Errata to IEEE Standard Criteria for Accident Monitoring Instrumentation for Nuclear Power Generating Stations

Correction Sheet

Issued 20 February 2003

Figure 1— Display channel

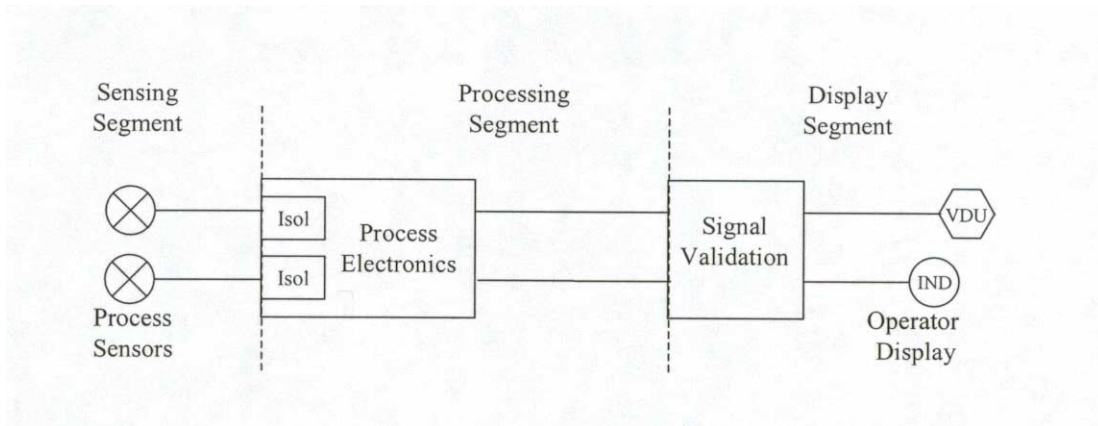
Page 5, Figure 1—Display channel, is incorrect. The figure should read as follows:

Figure 2—Examples of monitoring channel displays

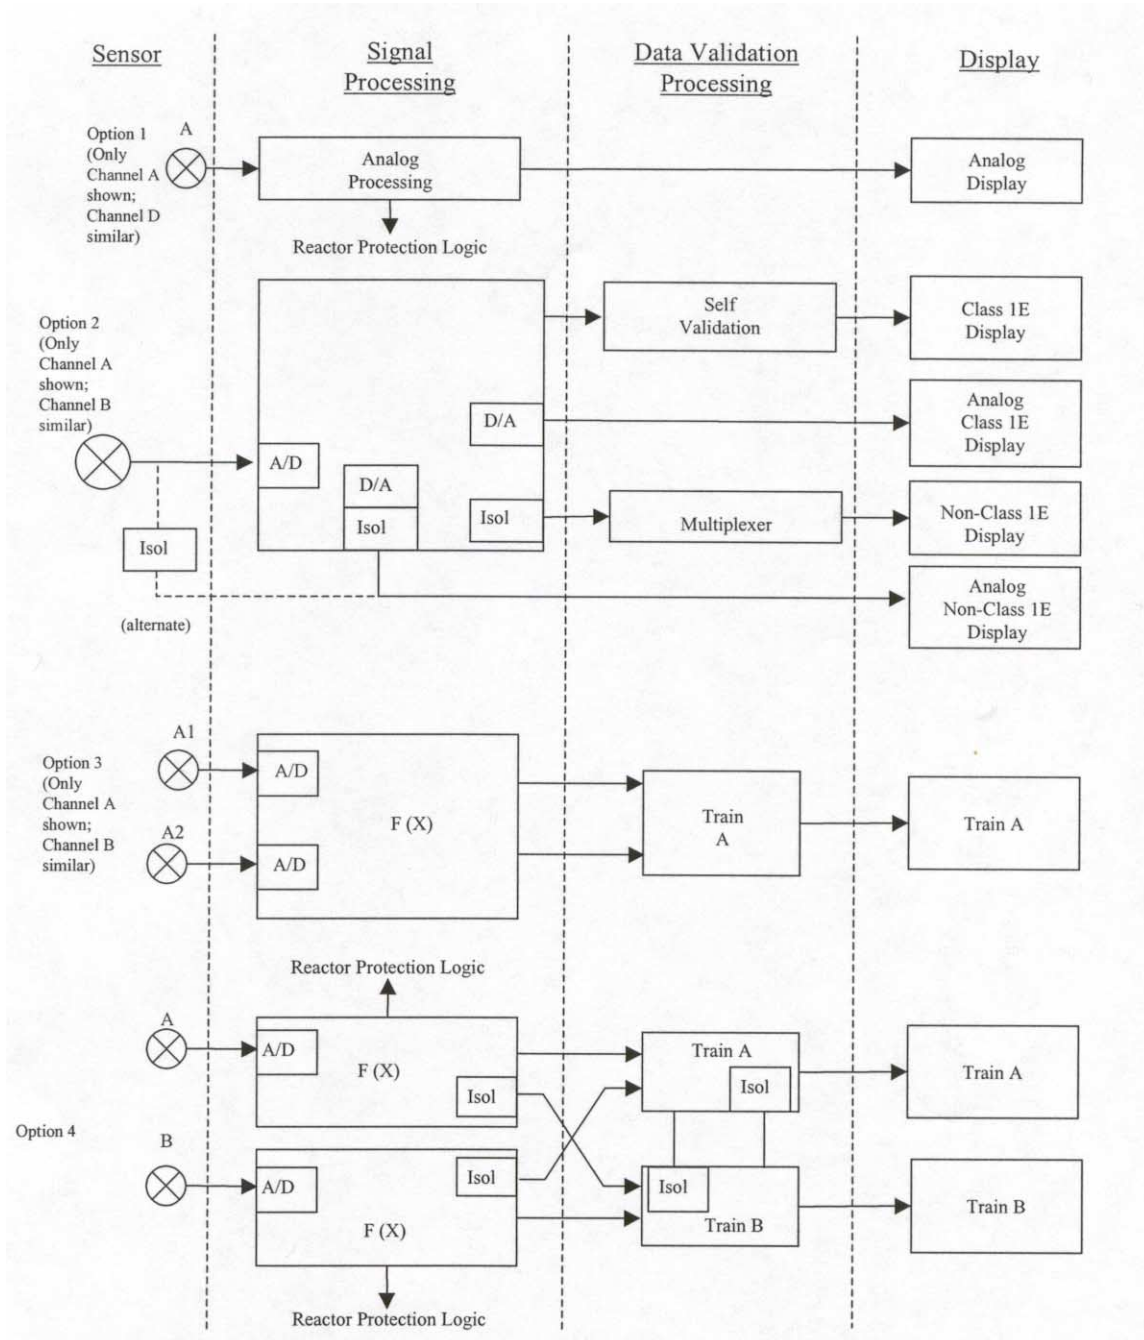
Pg 16, Figure 2— Examples of monitoring channel displays, is incorrect. The figure should read as follows.
